LINOTYPE IMPROVEMENT INFORMATION SHEET

NO. 334

F-8975 CABLE AND GUARD, ASSEMBLED

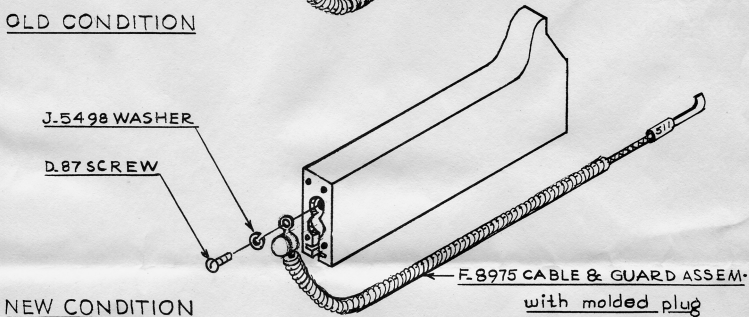
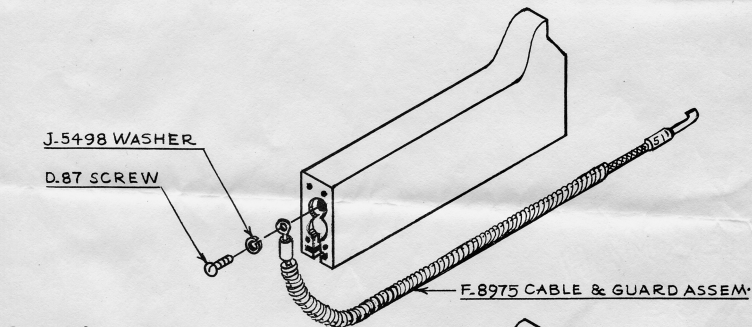
The Hydraquadder Left-Hand Vise Jaw and Guard, has been improved by molding a plastic plug around the wire terminal. The plastic plug holds the wire terminal in place and prevents the possibility of grounding, thereby causing false operation of the pot pump safety.

Can be applied to Outstanding Linotypes equipped with the Hydraquadder by ordering the F-8975 cable and guard which now includes the plastic plug.
